STAFF REPORT

AGENDA ITEM: Approve Parking Restriction Guidance Policy and Revisions to the Sign Plan in

Fields of St. Croix 1st Addition

SUBMITTED BY: Jack Griffin, City Engineer

LILAC WAY NORTH

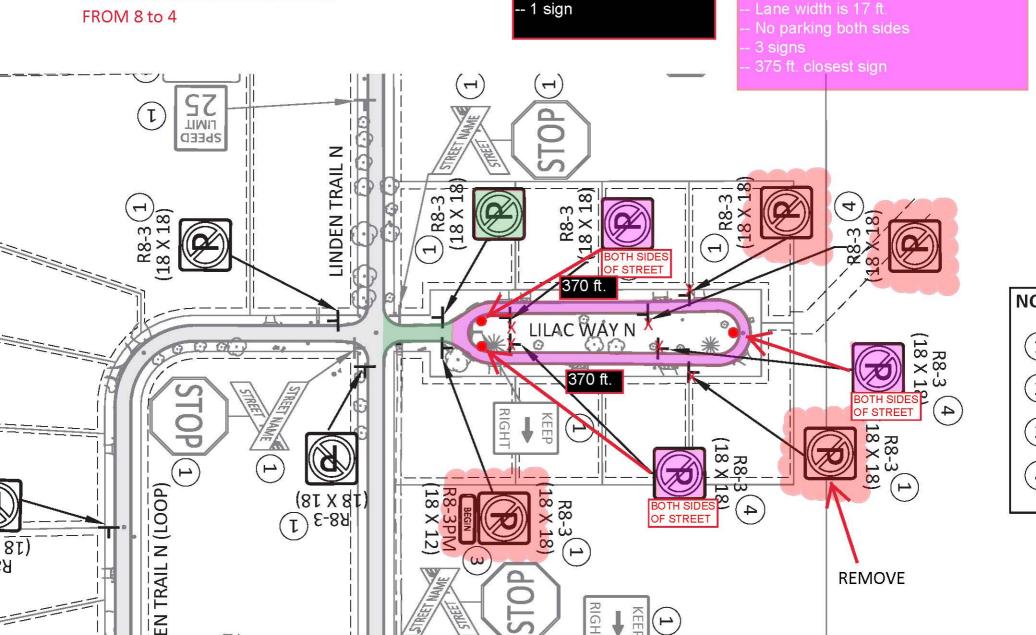
PLAN CHANGES REDUCES #SIGNS FROM 8 to 4

- 95 ft. Parking one-side

885 ft. Loop Street

LILAC WAY NORTH LILAC WAY NORTH PLAN CHANGES REDUCES #SIGNS - 95 ft. Parking one-side - 885 ft. Loop Street - 1 sign -- Lane width is 17 ft. FROM 7 to 4 - No parking both sides - 370 ft. closest sign CINDEN TR. RIGHT KEEP)R8-3 18 X 18) 4 4 LILAC PLACEN 370 ft. BOTH SIDES OF STREET (81 X 81)< R8-3 (18 × 18) , R8-3 (18 X 18) BOTH SIDES OF STREET KLARKSPUR MENUR R8-3 (18 X 18) R8-3 (1)(18 X 18)

- Relocate 3 signs per the attached exhibit and add placards to the 3 signs "BOTH SIDES OF STREET".
 - Remove 4 existing no parking signs as depicted on the exhibit.
